Riverside Theatre Parramatta

Access Review v2

(Job Number 01352)

22 November 2024

5.3 Stairs & Ramps

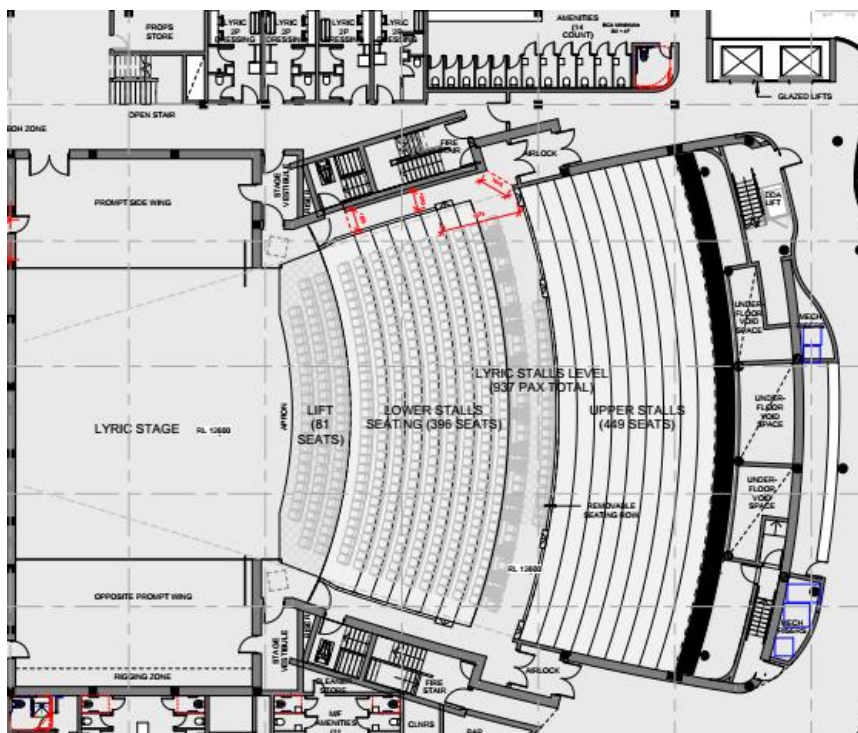
MGAC has reviewed the drawings and documentation in relation to the aforementioned requirements. On the basis of the current level of detail all access requirements appear capable of achieving compliance. Further work will be required during design development stage to ensure appropriate outcomes are achieved.

6.1 Lyric Theatre

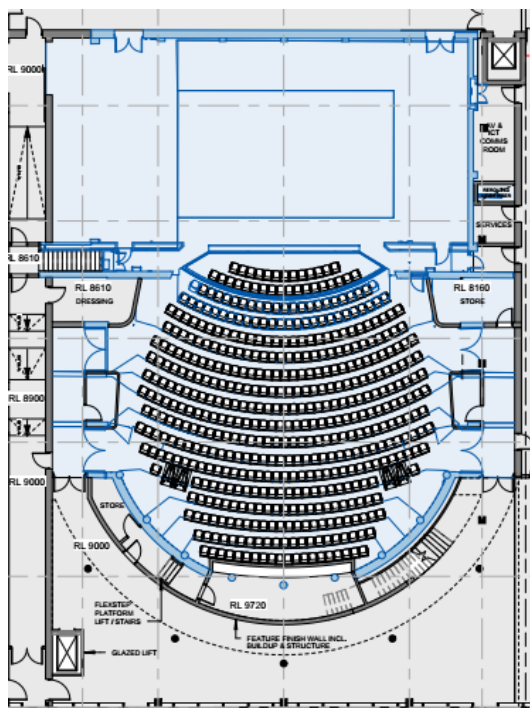
MGAC has reviewed the drawings and documentation in relation to the aforementioned requirements. There are groups of accessible seating and companion seating between upper and lower stalls. It is noted that the removable seating should not be located behind the accessible seating.

There is accessible seating above the upper stalls adjacent the VIP room. The total numbers of accessible seating is suitable under NCC.

There is suitable accessibility to the stage area within BOH.

6.2 Playhouse Theatre

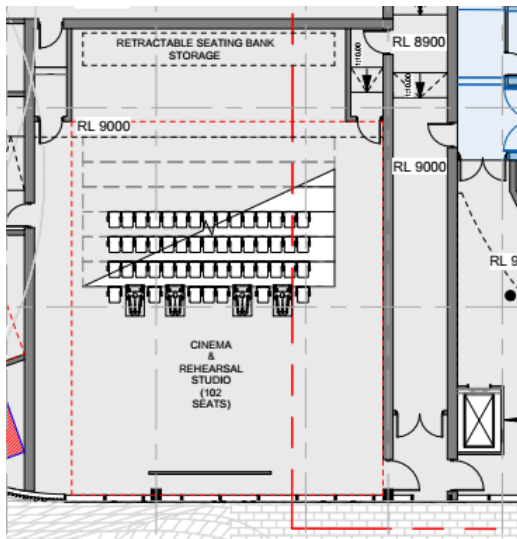
MGAC has reviewed the drawings and documentation in relation to the aforementioned requirements. There are groups of accessible seating and companion seating on all levels with accessible paths of travel leading to them. There is suitable accessibility to the stage area within BOH.
